# APPENDIX 3 – EXISTING DISABLED PERSONS PARKING PLACES TO BE AMENDED

INTRODUCE AMENDMENTS TO EXISTING  
DISABLED BAY  
LOCATION: Granton Terrace

INTRODUCE AMENDMENTS TO EXISTING  
DISABLED BAY  
LOCATION: Glendevon Place

Drawing: Appendix 3-loc 34003314  
Date: February 2022

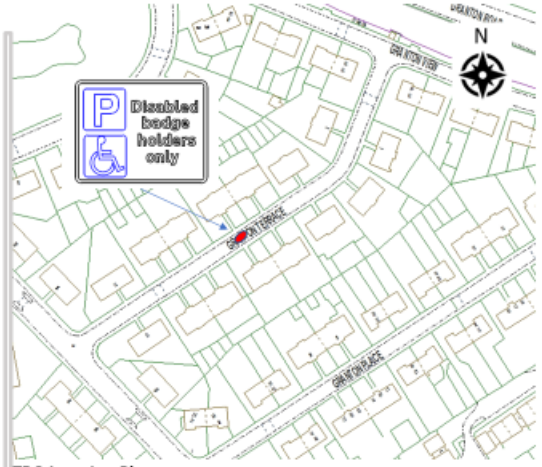
**Location of existing DPPP to be extended: 8 Granton Terrace**  
(\*\* DPPP marked at a sub-standard size)

Extend existing DPPP outside 8 Granton Terrace for a distance of 6.6m north-east.

**\*\* Not safe to extend the bay 2.7 metres out on to the carriageway.**

Drawing: Appendix 3-loc 34004688  
Date: February 2022

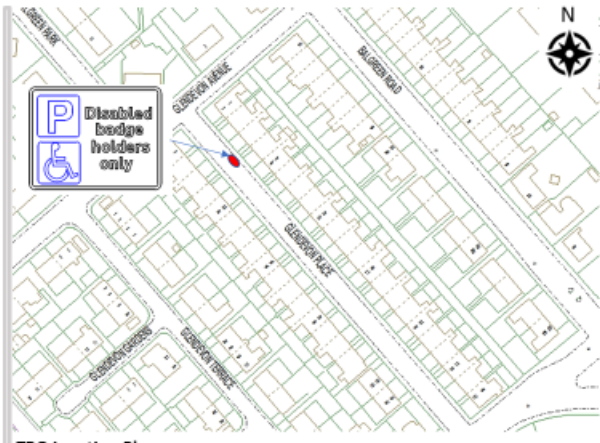
**Location of existing DPPP to be extended: 11 Glendevon Place**  
(\*\* DPPP marked at a sub-standard size)

Extend existing DPPP outside 11 Glendevon Place for a distance of 3.0m South-east and a width of 2.4m.

**\*\* Not safe to extend the bay 2.7 metres out on to the carriageway.**
